**WATER SUPPLY EVALUATION
FOR PROPOSED PROJECTS
ALONG THE I-84 CORRIDOR**

Idaho Power Company

David B. Shaw and Norman C. Young

November 14, 2012

Figure 2

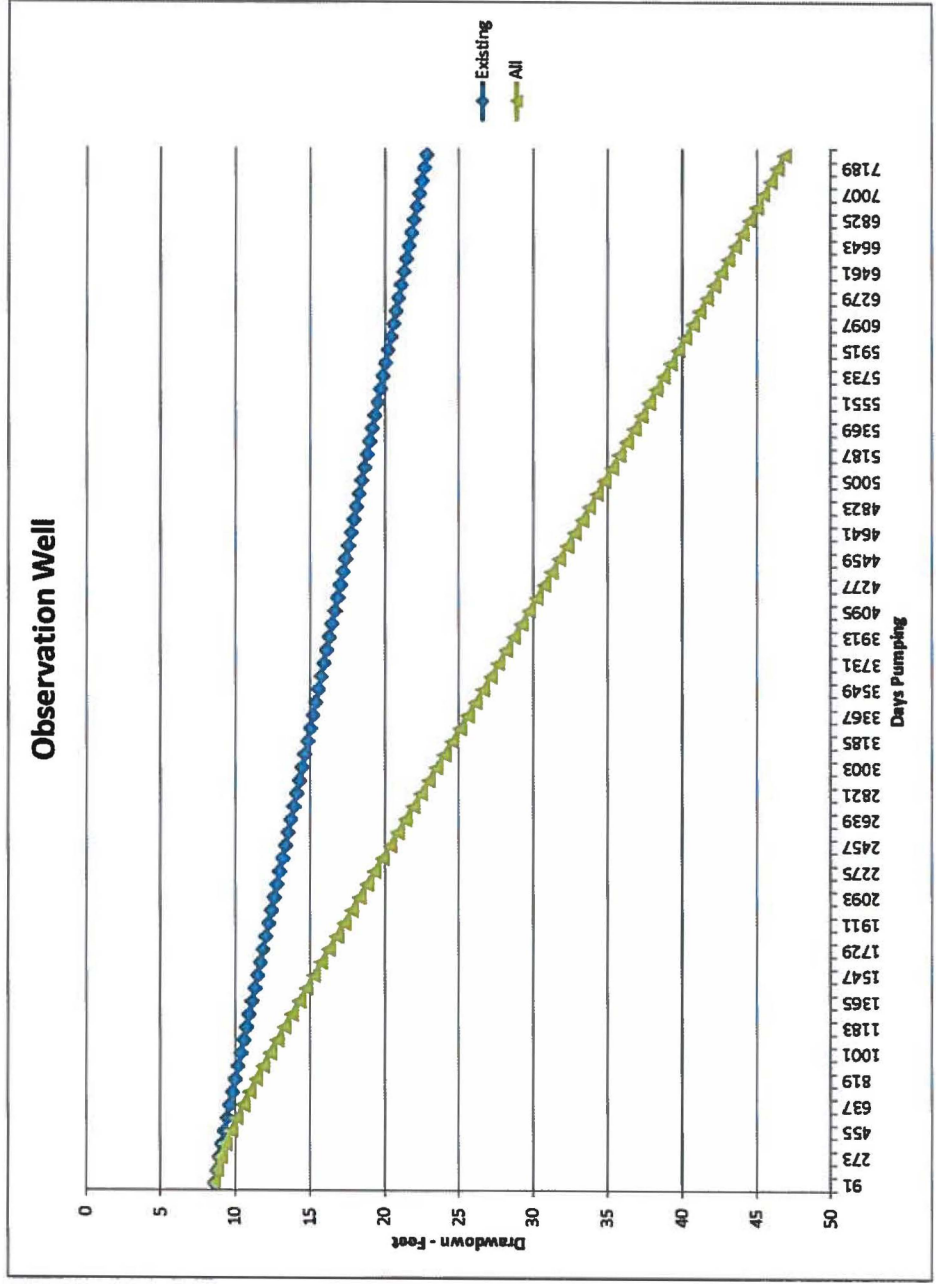
To estimate the impact of continued pumping by existing water users the program was run for an additional 20 years. A simulated observation well was placed near the center of Sec 19 Twp 1S Rge 5E, B.M. which is near the location of the fault identified by Bond and near the boundary of the study area and the comparison area². The results of the additional simulated pumping are shown in Figure 2 below. The analysis shows an estimated drawdown at this location of about 8 feet after 20 years of pumping the existing wells. When pumping of those wells continued for the second 20 years the analysis shows an increased rate of drawdown of about 15 feet for a total drawdown of about 23 feet by existing water uses after 40 years of pumping.

The existing permits, transfers and new water right applications were then added to the analysis and the second 20 year simulation was run a second time. The projected drawdown is shown on Figure 2 below as "All" and shows a drawdown of about 47 feet in the second 20 years, about double the drawdown that is forecast if existing conditions remain unchanged.

Figure 3

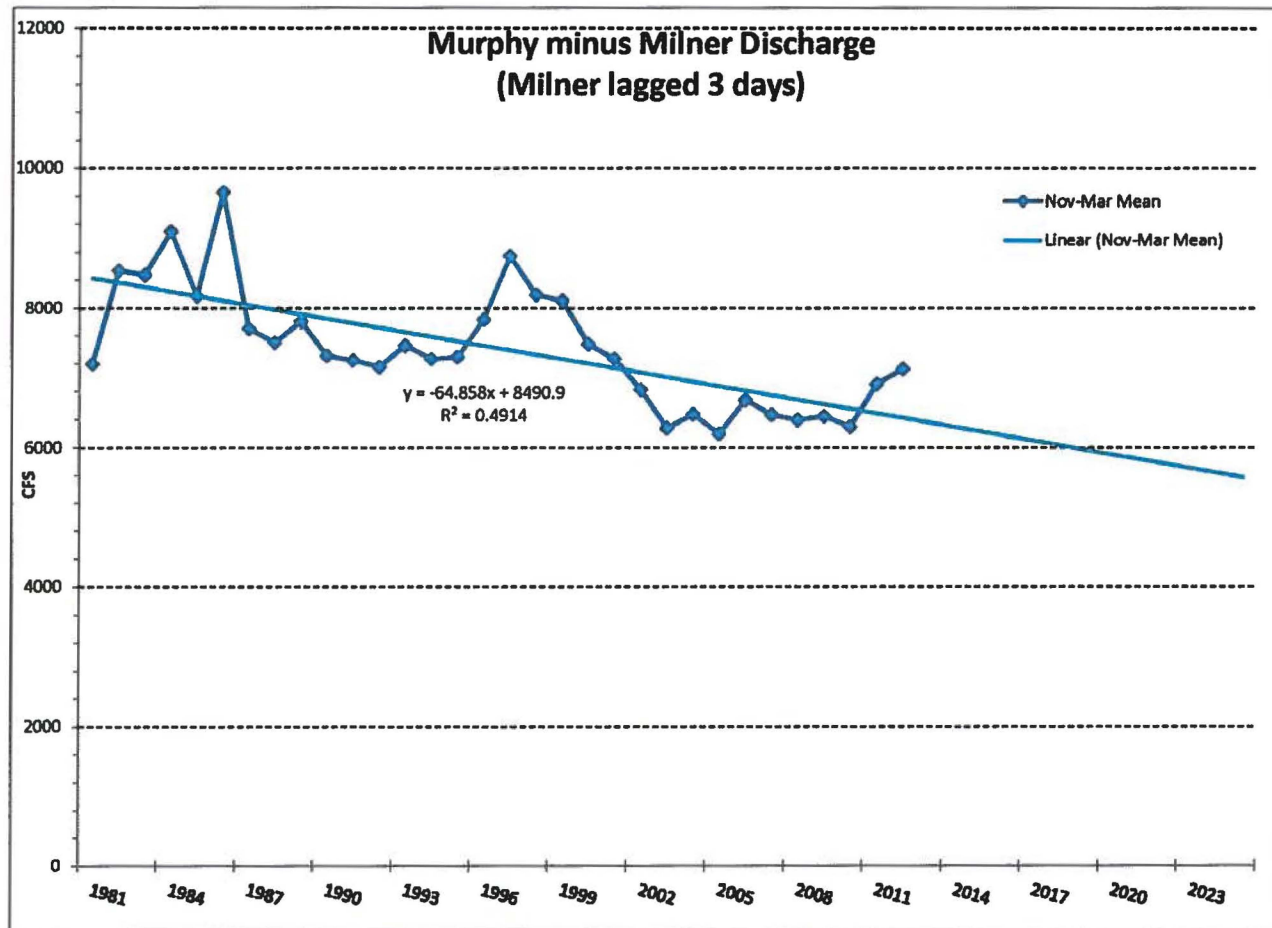
Figures 3 and 4 below were produced using mean daily flows for Murphy and Milner, modified as described above, and averaged for the winter and summer periods respectively. Figure 3 suggests the average mean daily winter discharge at Murphy, as modified above, has declined about 2,000 cfs since 1981 and is continuing to decline at about 65 cfs per year. Projecting this rate of decline forward from 2012 for 13 years suggests the average mean daily flow for the winter of 2025 will be 5,600 cfs, the winter minimum flow established by the Swan Falls Agreement and approved by the Idaho Legislature.

Figure 4

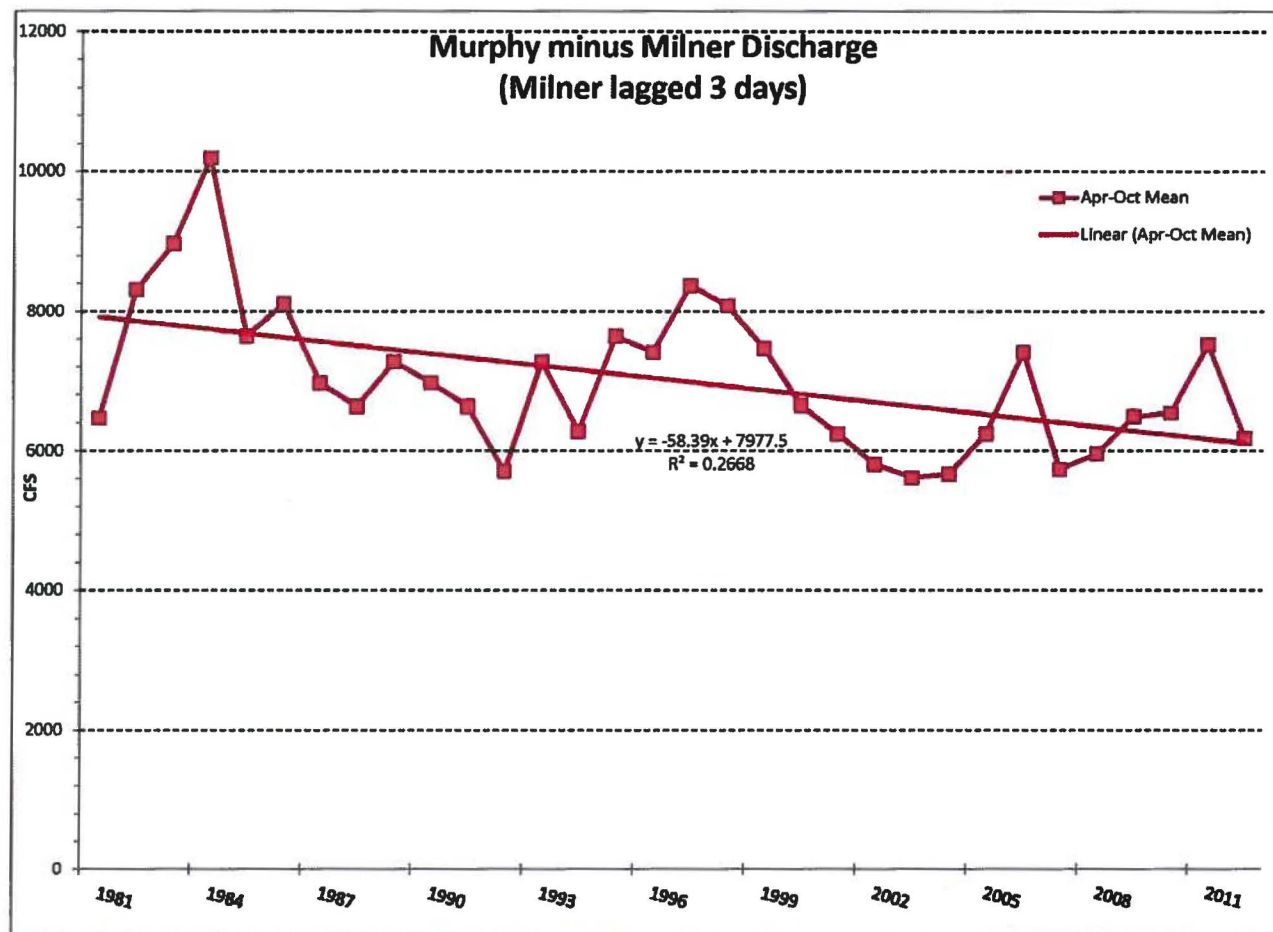
Figure 4 suggests the average mean daily summer discharge at Murphy, as modified above, has declined about 1,850 cfs since 1981 and is continuing to decline at about 58 cfs per year. The average summer flows are still high enough there is no immediate danger the entire average summer flow will decline to 3,900 cfs, the summer minimum flow established by the Swan Falls Agreement and approved by the legislature. Summer flows are, however, quite variable, and time periods shorter than the 7 months from April through October were examined to determine if one period was consistently lower than the entire summer period. To perform that analysis, monthly averages of mean daily summer flows at Murphy, as modified, were calculated for the months April through September with the lowest month being July.
